Architect's Supplemental Instructions

PROJECT:
Summit Square
Apartments Phase II
 837 NW Donovan Road
 Lee's Summit, MO 64086

ARCHITECT'S SUPPLEMENTAL
INSTRUCTION NO.: 16

At the Owner's request, an addition to serve as the Parcel Storage room was added to Building 1. Additional revisions and clarifications to the scope are summarized per sheet, and reason for the change where applicable:

A1.44

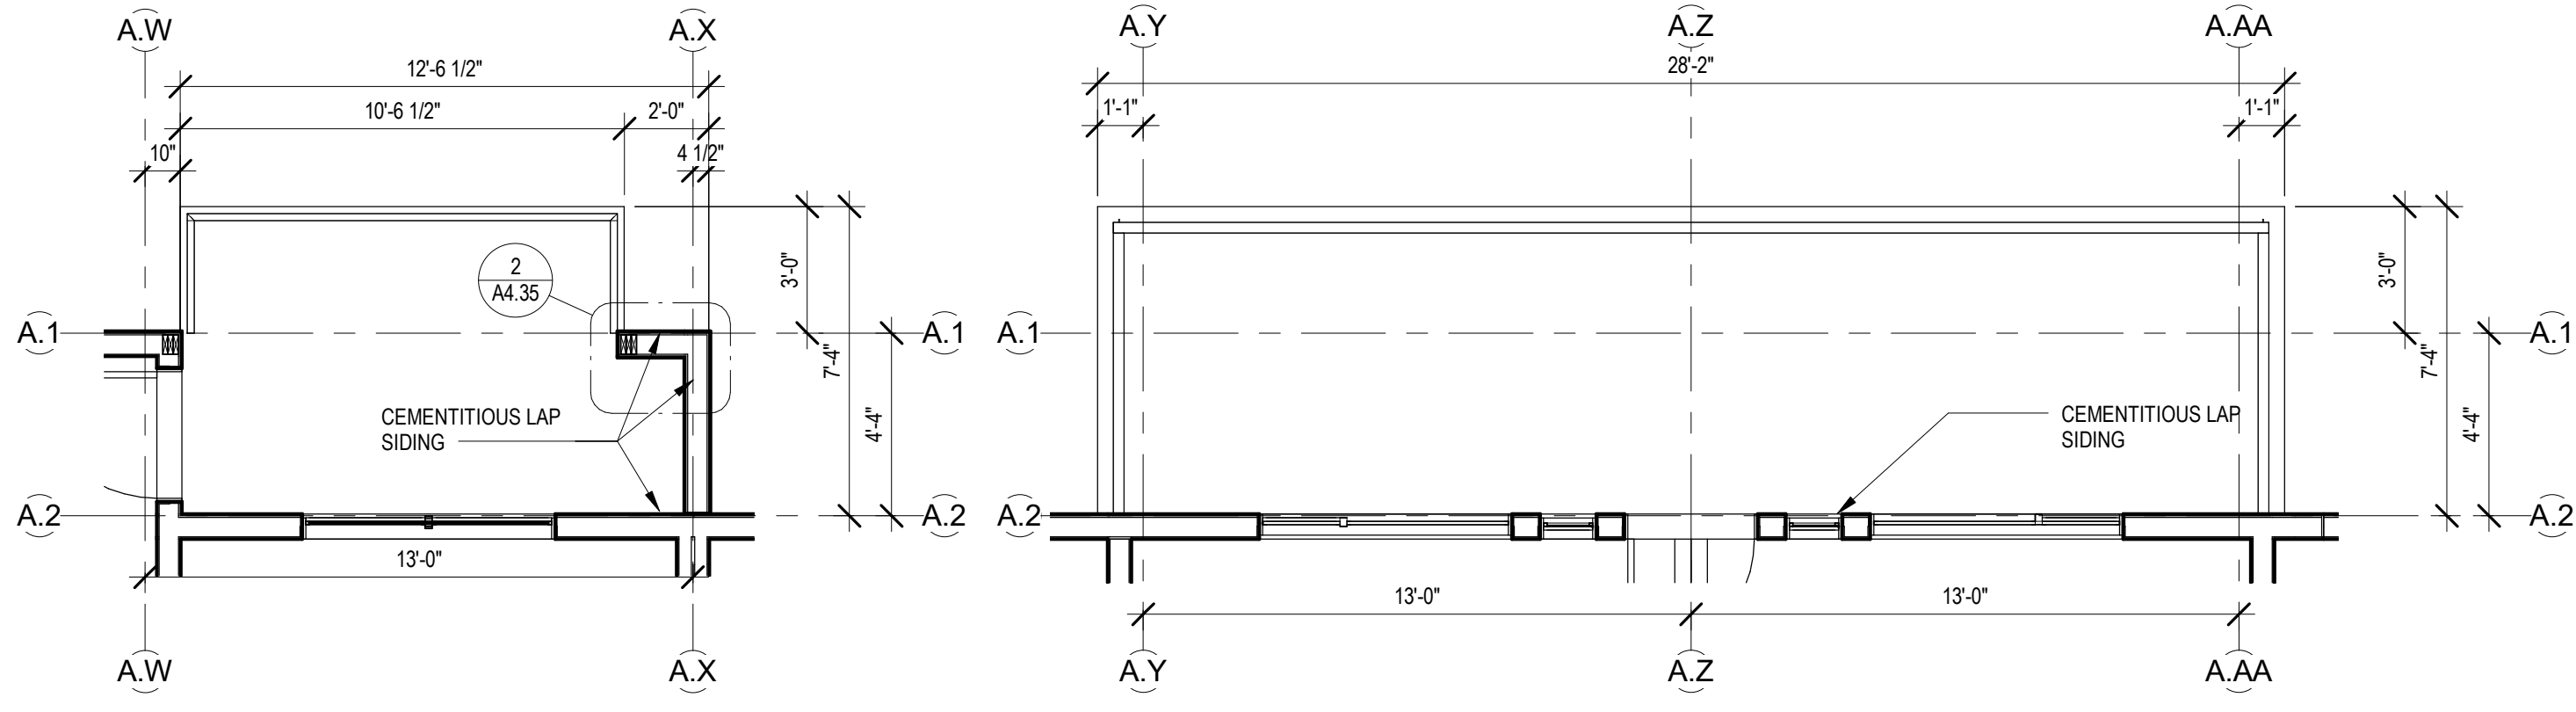
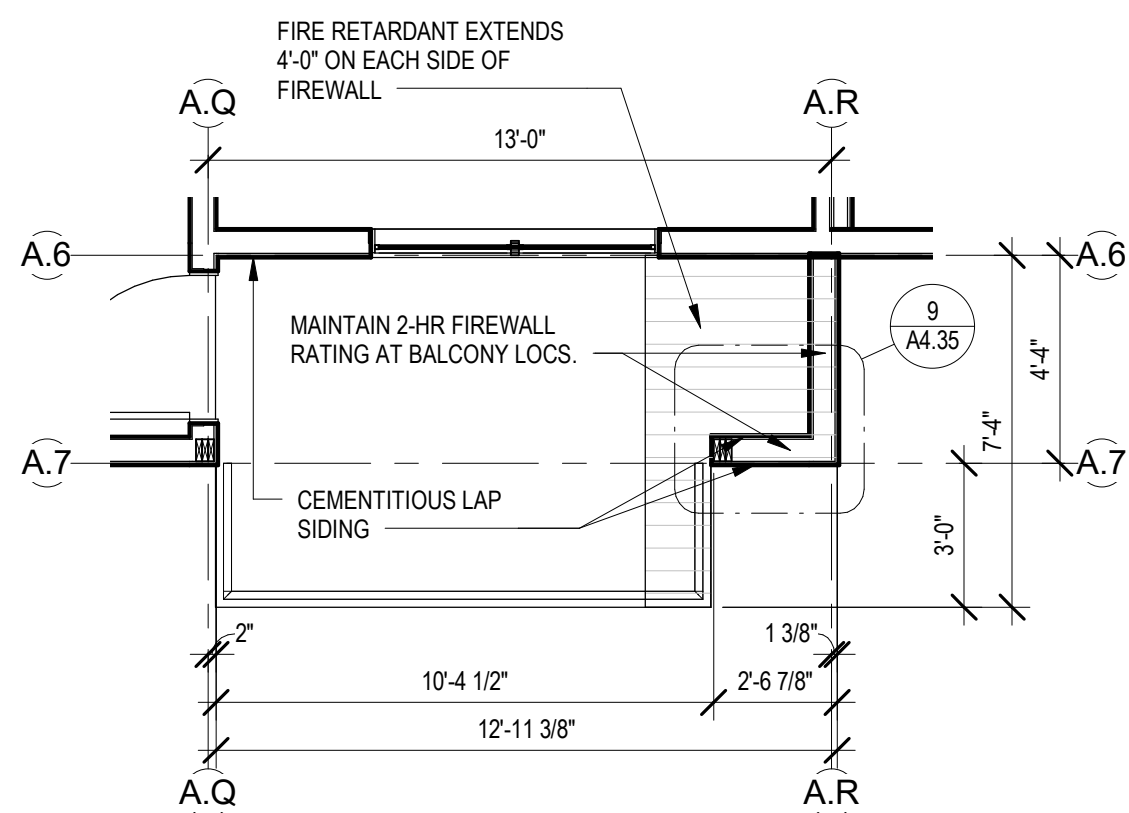
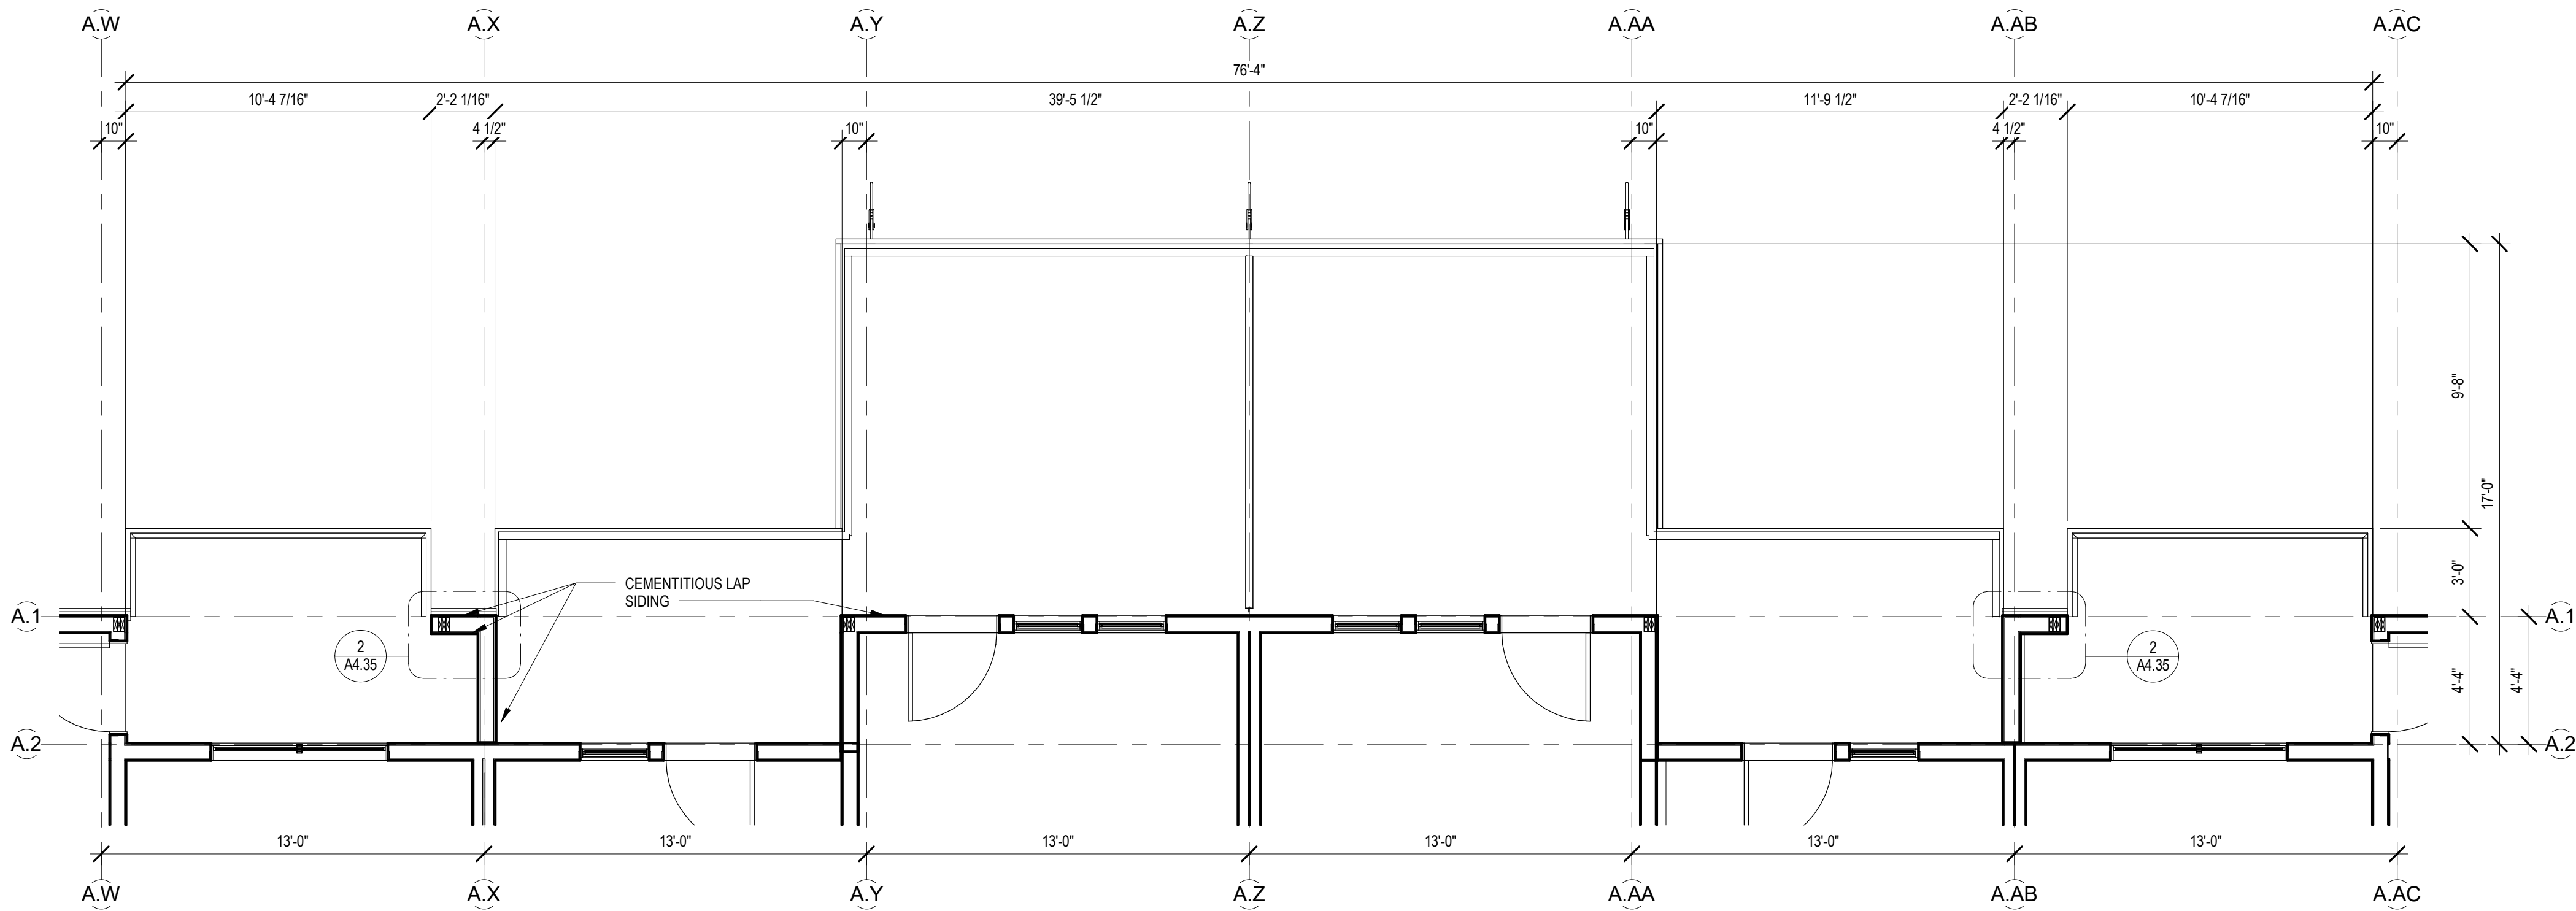
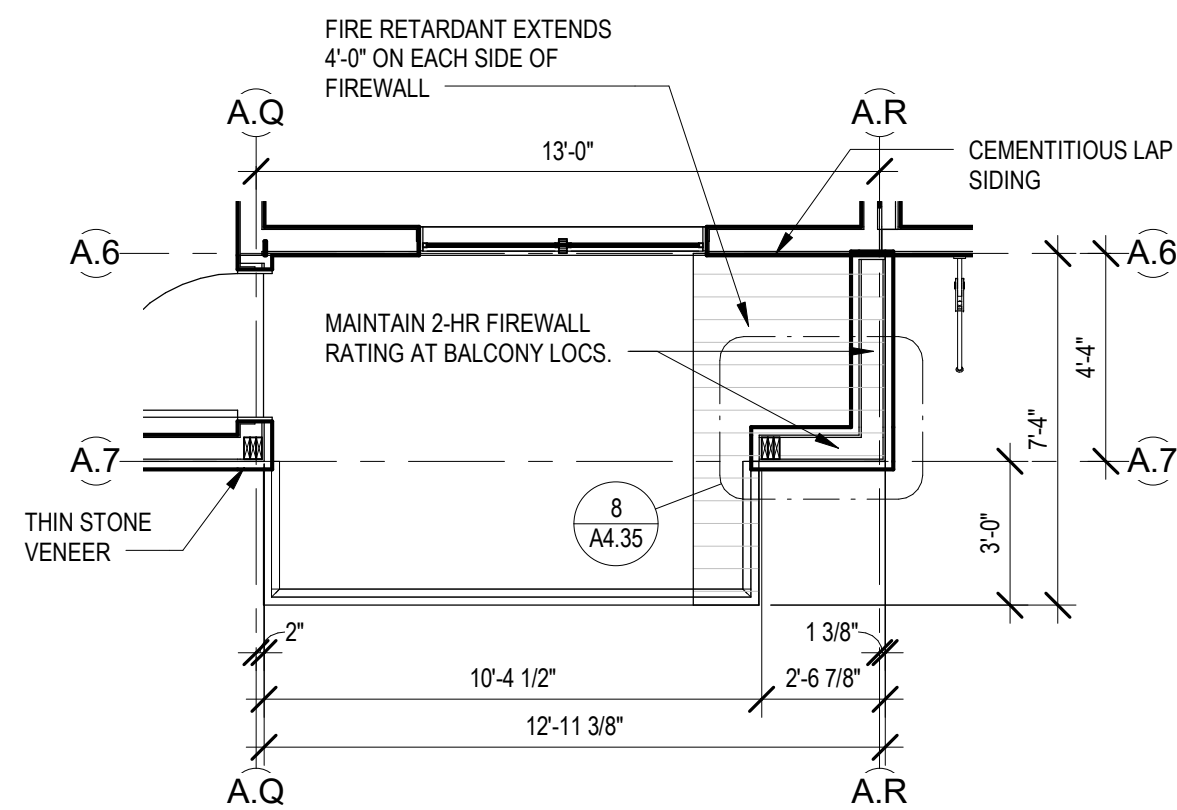
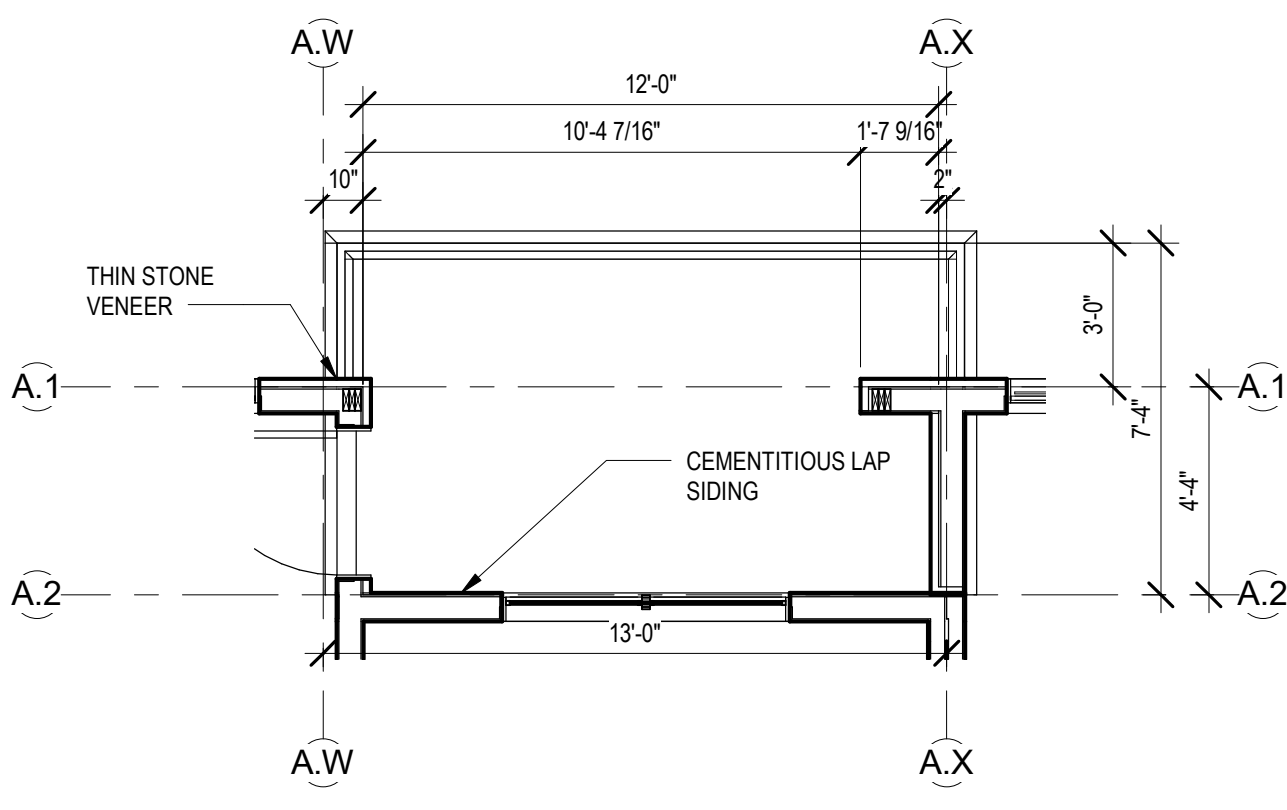
- A1.31 *Revise closet shelving; Add scribe mold location at kitchen island*
- A1.44 *Add detail 44—enlarged balcony per addition of Parcel Storage room*

A2.10SB

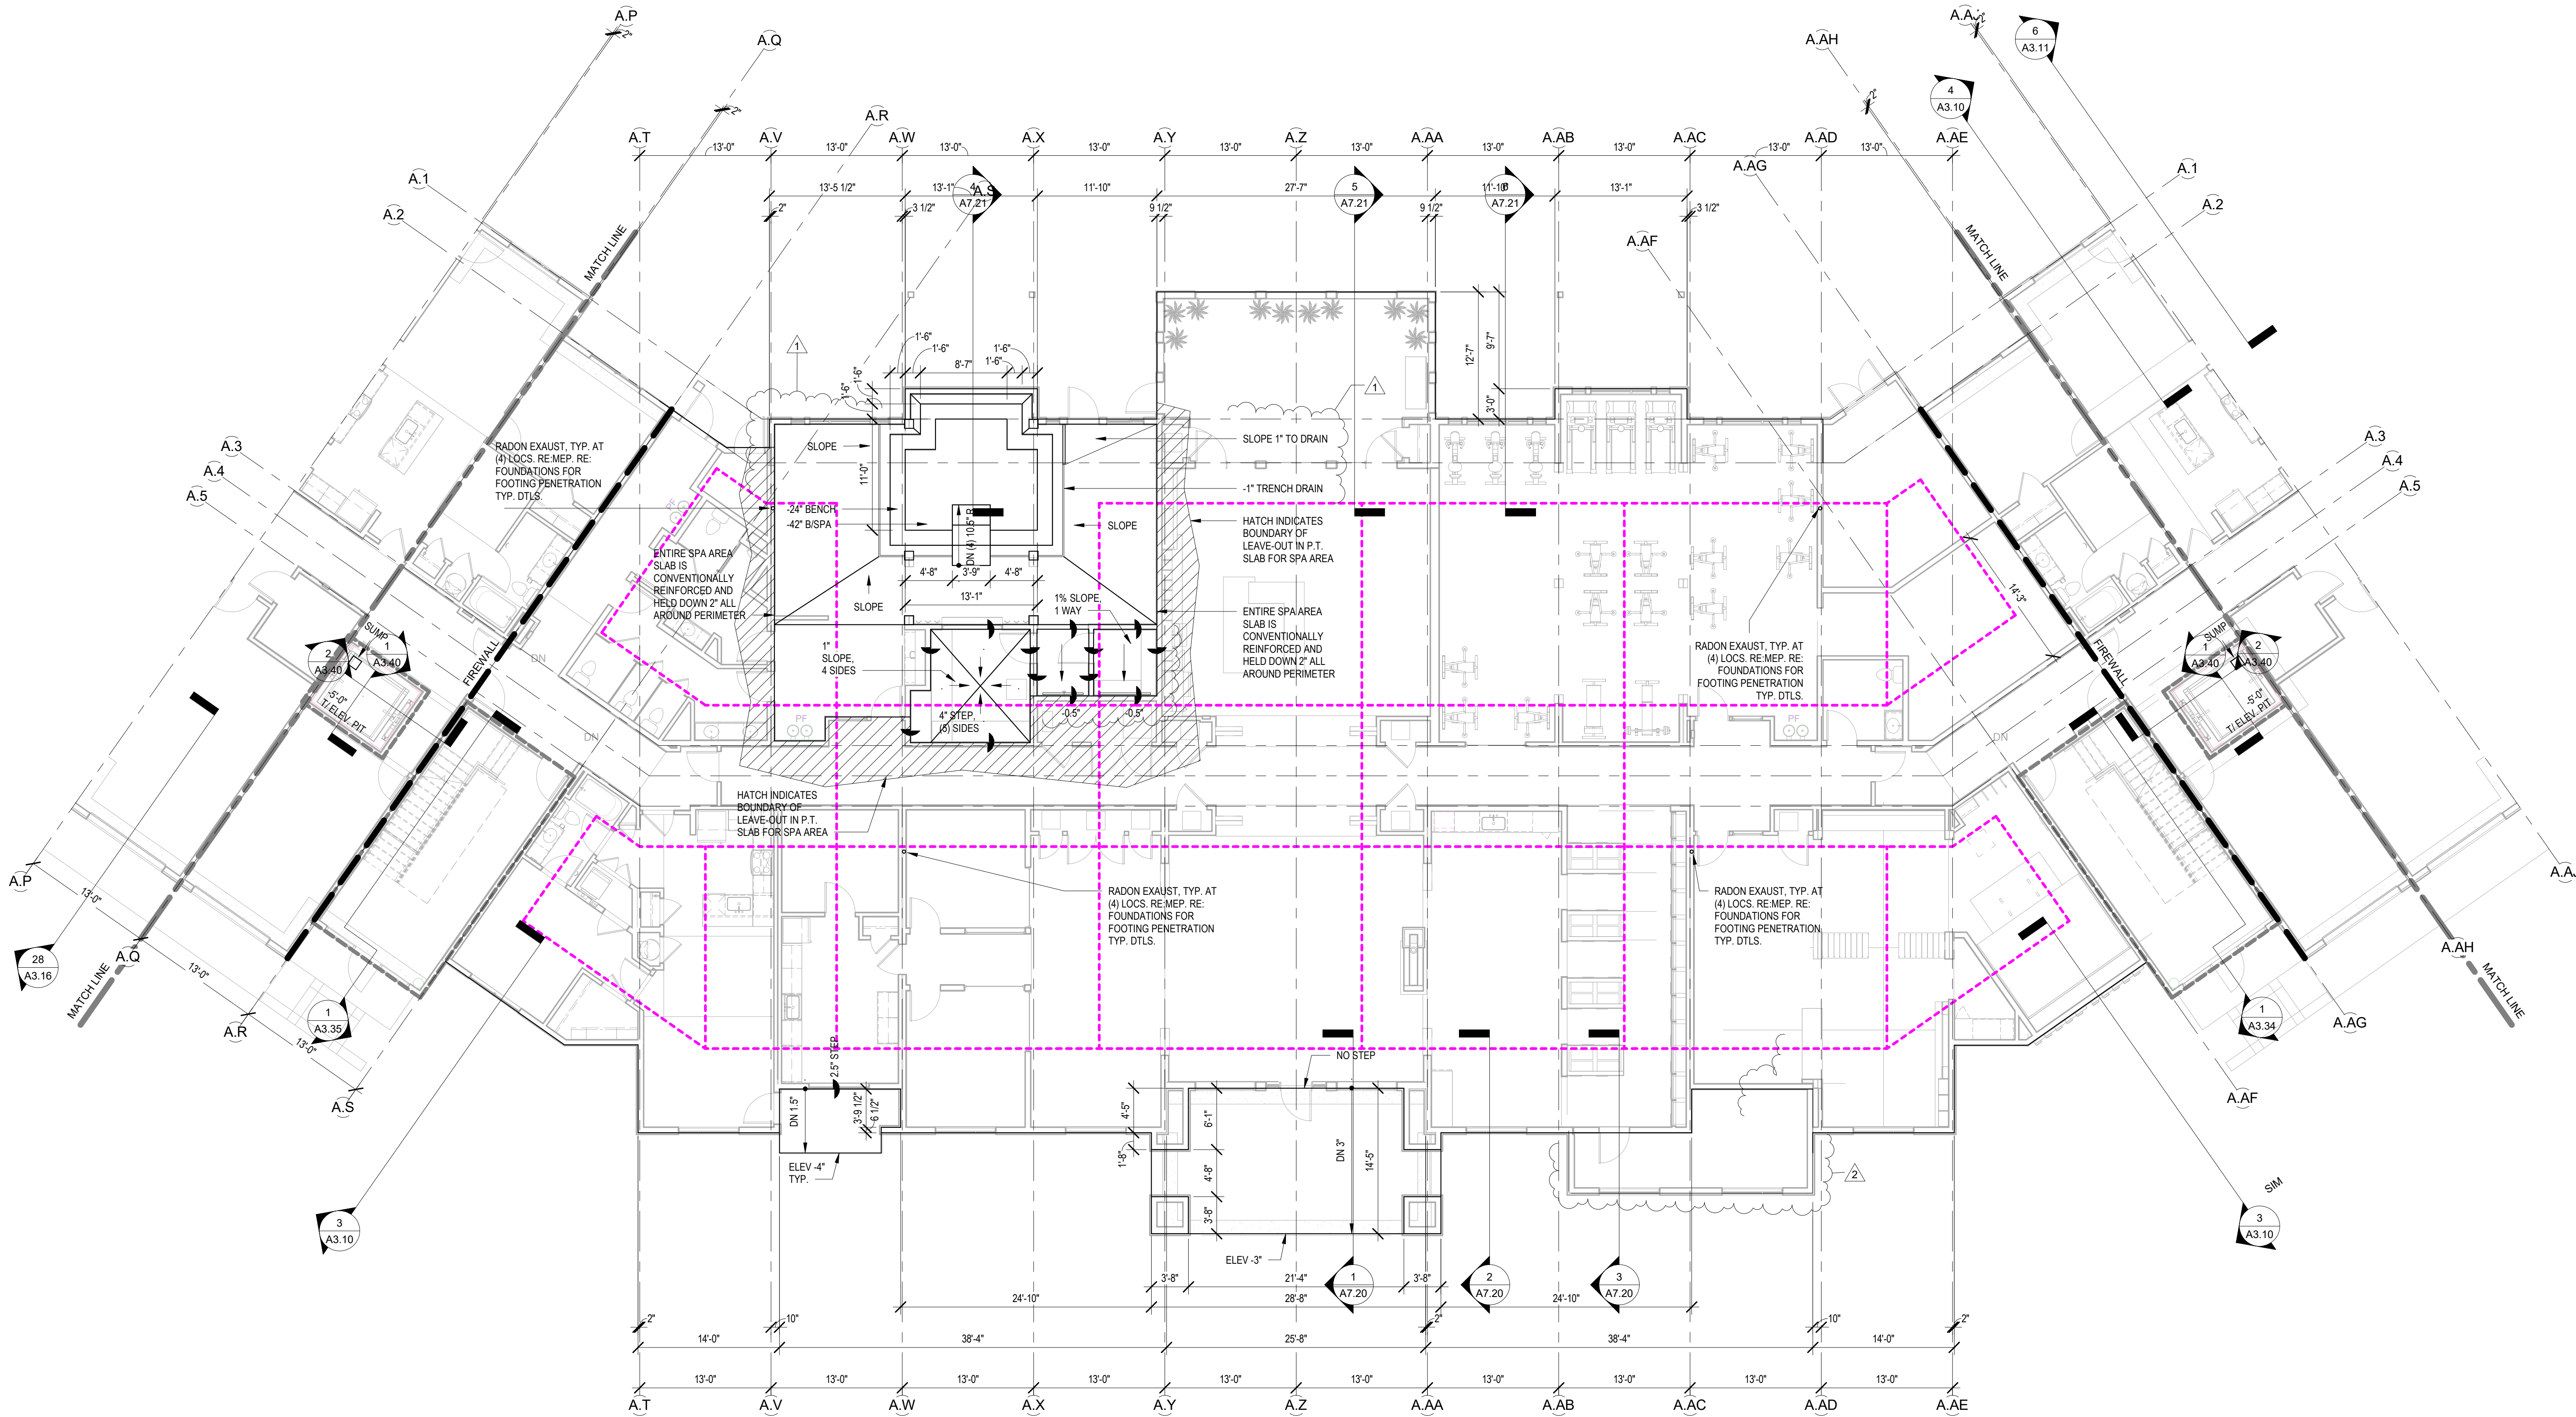
- A2.10B *Revised with Parcel Storage room addition*
- A2.10SB *Revised with Parcel Storage room addition*
- A2.11B *Revised with Parcel Storage room addition*
